STAFF REPORT

PLANNING & ZONING COMMISSION

Village Green Municipal Building, Council Chambers
47 Hall Street
Wednesday, February 14, 2018
7:00 P.M.

2. AMENDMENT TO A FINAL DEVELOPMENT PLAN REVIEW

Image 3 – Today's Proposed Plan

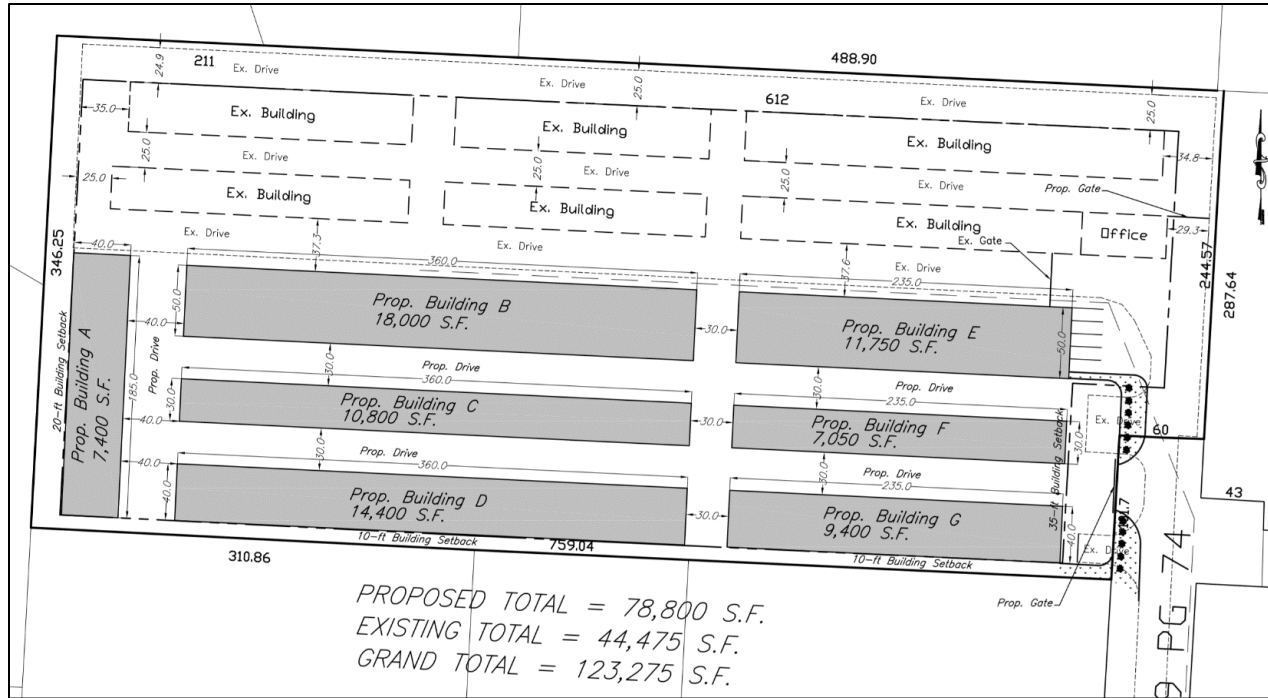
As stated above, the applicant is proposing new buildings and the removal of boat and RV storage from the site. The site plan below (Image 3) shows the construction of seven new structures with no parking for recreational vehicles. Not shown on the image is the removal of one structure in order to build the proposed buildings.

Overall, staff is in favor of this development. The construction of new storage buildings adds additional service to Powell residents and the construction of new buildings, as well as the removal of outdoor parking, will help lessen the visual impact to neighboring commercial and residential uses. Instead of seeing parked recreational vehicles, neighbors will see new and well-designed buildings. Also, the new buildings will help "fence off" the site and block it from the street. Thereby further lessening the impact of the site on neighboring uses. Lastly, the number and spacing of the buildings also seem reasonable as it is a more efficient use of site. The only issues from Staff's standpoint is that there will be Divergences to the Planned Industrial code as it relates to building coverage and total coverage by building and pavement, which should be set forth within the Development Plan text when submitted.

Staff recommends that the applicant continue through to the preliminary development plan stage of the development review process.
